Peach Bottom Atomic Power Station, Units 2 and 3
Renewed Facility Operating License Nos. DPR-44 and DPR-56
NRC Docket Nos. 50-277 and 50-278

Subject: MELLLA+ License Amendment Request – Supplement 3
Response to Request for Additional Information

**Responses to Reactor Systems Branch Request for Additional Information –
Non-proprietary**

**Responses to Reactor Systems Branch (SRXB)
Request for Additional Information**

Figure SRXB-RAI-2-1 - PBAPS Power Flow Map Showing SLMCPR Statepoints

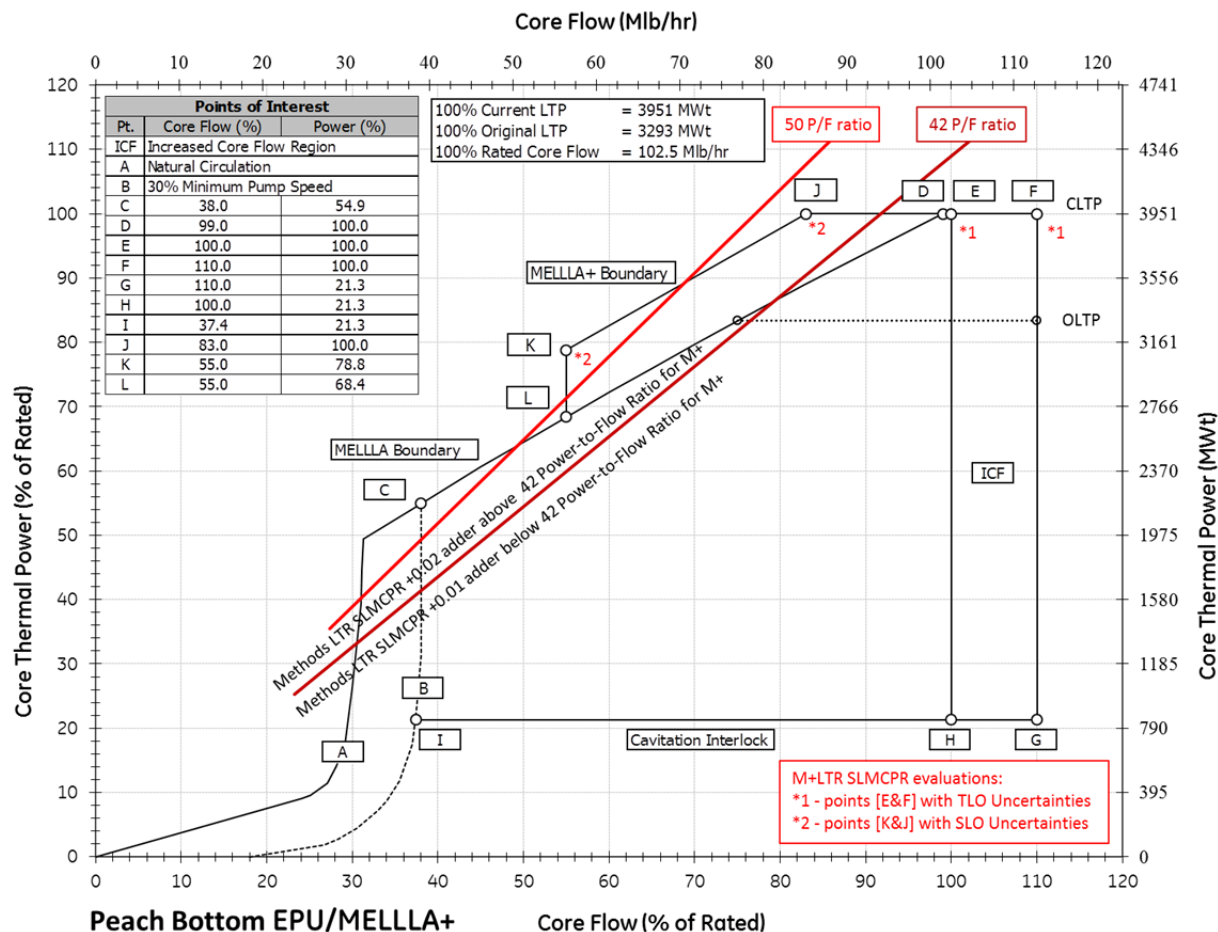
M+SAR Section 2.2.1, "Safety Limit Minimum Critical Power Ratio," states that "[t]he cycle-specific SLMCPR analysis will incorporate a +0.02 SLMCPR adder for MELLLA+ operation." Section 2.2.2 "Operating Limit Minimum Critical Power Ratio [OLMCPR]," states that "[w]ith the usage of TRACG-AOO instead of ODDYN the +0.01 adder to the resulting OLMCPR as required by Methods LTR SER Limitation and Condition 9.19 is no longer applicable and will not be applied to the OLMCPR."

Provide a list of SLMCPR and OLMCPR adders in MELLLA+ with respect to pre-EPU conditions. Specify which adders are part of the EPU upgrade, and which are MELLLA+ specific.

As the PBAPS MELLLA+ P/F map (See Figure SRXB-RAI-2-1) includes statepoints with a P/F ratio of greater than 42 MWt/Mlbm/hr, the SLMCPR will have a +0.02 adder applied. The PBAPS MELLLA+ analyses were performed using TRACG04 methods; thus, there are no OLMCPR adders required for EPU/MELLLA+ operation. The SLMCPR adder is MELLLA+-specific and is the same for PBAPS Unit 2 and PBAPS Unit 3.

Figure SRXB-RAI-2-1 shows a graphical depiction of the SLMCPR evaluation statepoints and Methods LTR SER SLMCPR adders based on the P/F ratio. The 100P/100F and 100P/110F cases are evaluated with two loop operation (TLO) uncertainties. The 100P/83F and 78.8P/55F cases are evaluated with single loop operation (SLO) uncertainties. Since SLO uncertainties cases (P/F ratio > 42 MWt/Mlbm/hr) will always be more limiting than TLO uncertainties cases (P/F ratio < 42 MWt/Mlbm/hr), the +0.02 adder has been conservatively applied to all calculated MELLLA+ SLMCPR results before establishing the most limiting SLMCPR required for the Technical Specification.

Figure SRXB-RAI-17-1 - Highlighted Content of M+SAR Figure 2-17

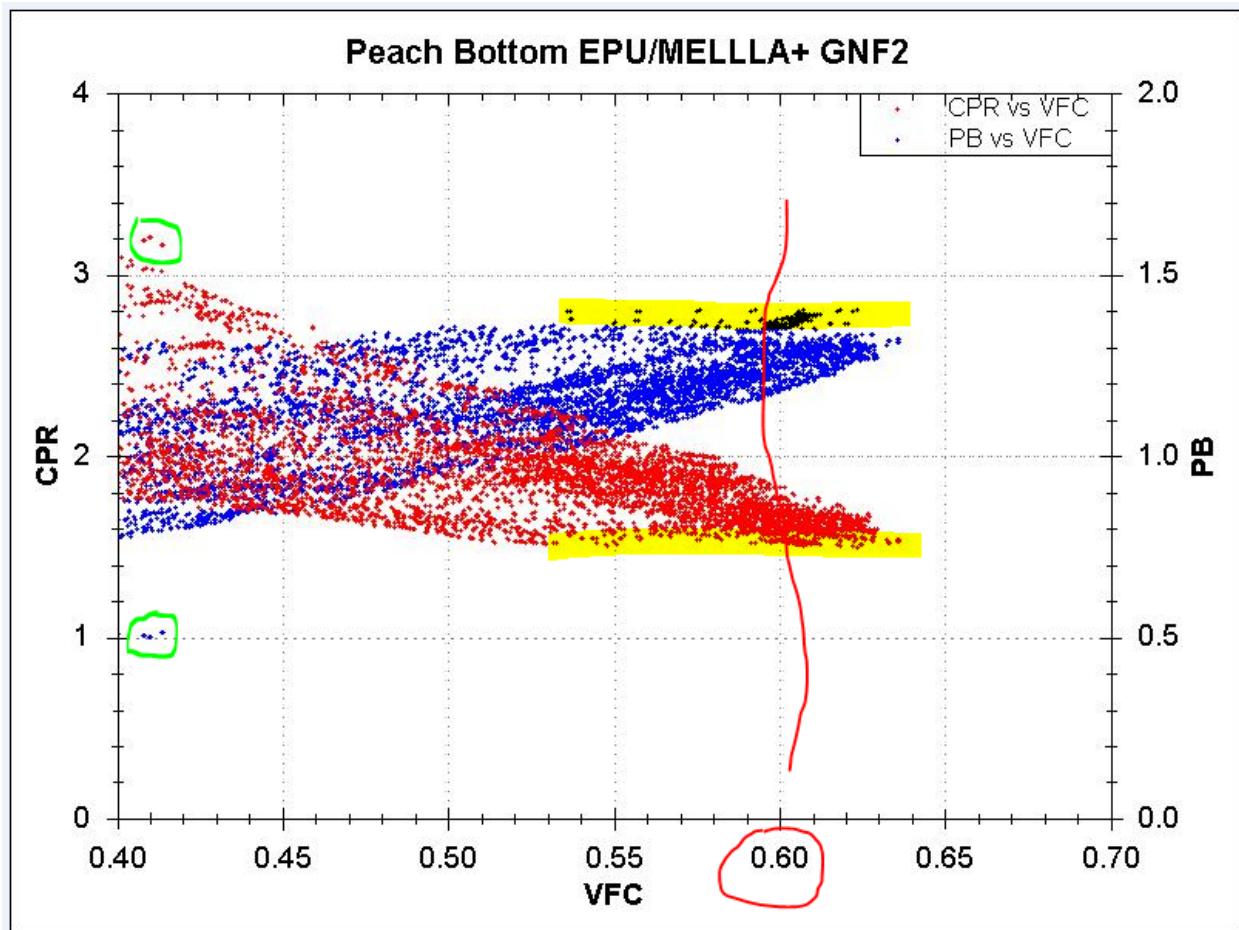
There are three outliers that are visually apparent in M+SAR Figure 2-17 at Integrated Bundle Power (PB) vs Bundle Average In-Channel Void Fraction (VFC) of about 0.5 and 0.41, respectively. Provide a discussion on these and any other outliers in Figure 2-17.

The purpose of M+SAR Figure 2-17 is to address Methods LTR SER Limitation and Condition 9.6 (NEDC-33173P-A, Revision 4) by showing the VFC corresponding to the bundles with the lowest critical power ratio (CPR) or highest bundle power (PB). The region of importance is above 50% VFC for EPU cores. The bundles with the lowest critical power margin and highest bundle power (i.e., hot channel) correspond to the data points highlighted in yellow in Figure SRXB-RAI-17-1. The yellow highlighted data points should be around 60% VFC (as noted by the red line indication) to confirm the appropriate hot channel axial average void condition is used in the R-factor calculation.

M+SAR Figure 2-17 is typically plotted for data points from 40% to 70% VFC to capture bundles with CPR less than 2 and PB greater than 1. Data points below 40% VFC are typically bundles near or on the core periphery and have CPR greater than 2 and PB less than 1. The perceived outliers described in the RAI (see green highlighted data points in Figure SRXB-RAI-17-1) are not outliers based on correlation fitting, but are representative of lower powered bundles on or near the core periphery. Lower powered bundles will have lower axial average void conditions and thus greater critical power margin. These perceived outlier data points are not in the region of interest for confirming the appropriate hot channel axial average void condition are used in the R-factor calculation.

The data points in M+SAR Figure 2-17 are generated for every bundle in the core (764) at every statepoint (51) evaluated in the equilibrium cycle, for a total of 38,964 data points for both CPR vs VFC and PB vs VFC series values. The complete data range is shown below in Figure SRXB-RAI-17-2, with the area extracted to complete M+SAR Figure 2-17 highlighted with the light blue outline.
